PHILADELPHIA ELECTRIC COMPANY

SUBJECT: Supplement to Repair to the Jet Pump
Instrumentation Penetrations

PHILADELPHIA ELECTRIC COMPANY
PEACH BOTTOM ATOMIC POWER STATION
UNIT 3

JULY 23, 1984 REVISIONS TO ATTACHMENT C
SAFETY EVALUATION FOR THE OPERATION OF
PEACH BOTTOM ATOMIC POWER STATION
UNIT 3

FIGURE 1

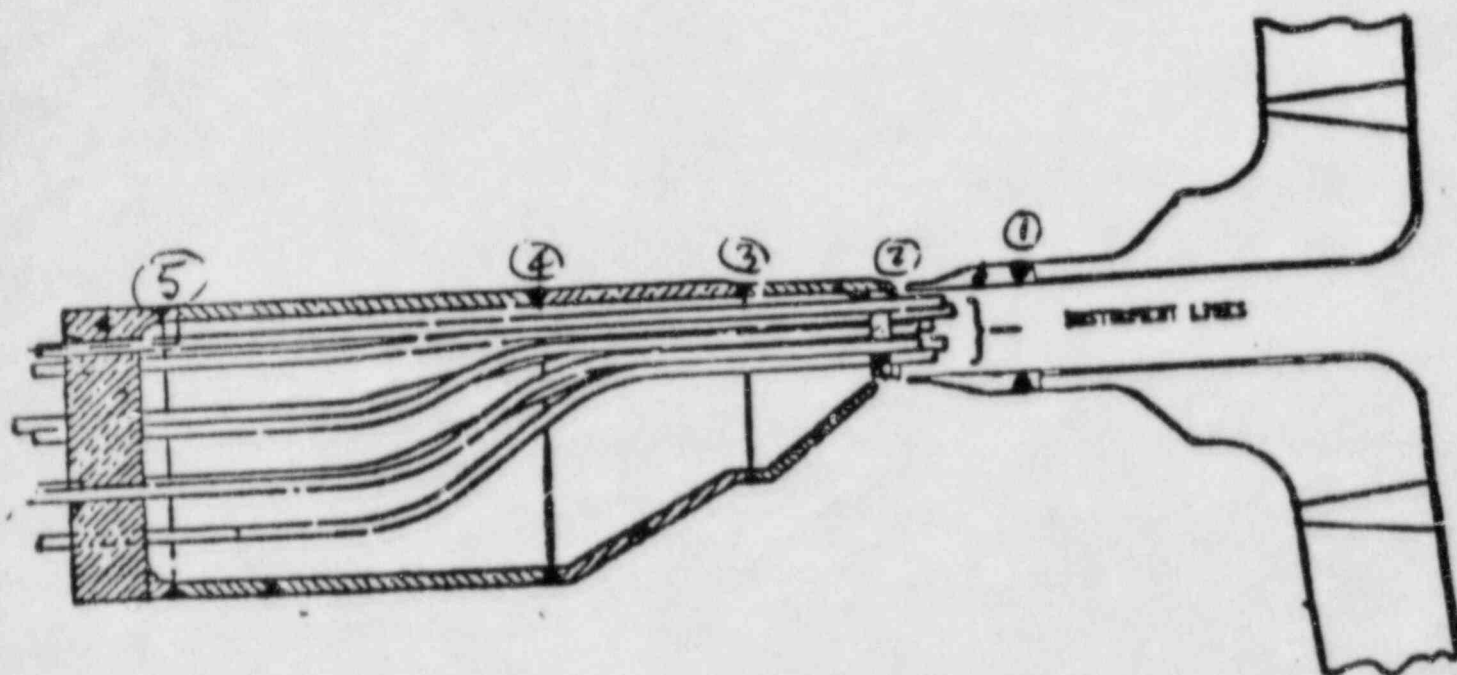
The "A" loop circumferential indication was in the 12 o'clock position on the safe-end side of the No. 2 weld. The "B" loop circumferential indication with three pin-hole leaks was in the 12 o'clock position on the reducer side of the No. 2 weld. The pipe material of the eccentric reducer and the safe end at both locations are ASTM A182-F304 and ASTM A336-F8, respectively. Both components are 4" nominal, forged Schedule 80 TP-304 Stainless Steel. The minimal wall thickness of these piping components is 0.337".

General Electric Company recommended applying a 0.125" thick by 1.5" wide full circumferential overlay on each weld to assure leak-free operation for a minimum of 18 months of full power operation.

The overlay design applied to these welds is conservative since it was designed to accommodate a hypothetical through-wall crack, 360 degrees in circumference. The overlay weld as applied is a full structural overlay and meets all the requirements of NRC Generic Letter 84-11.
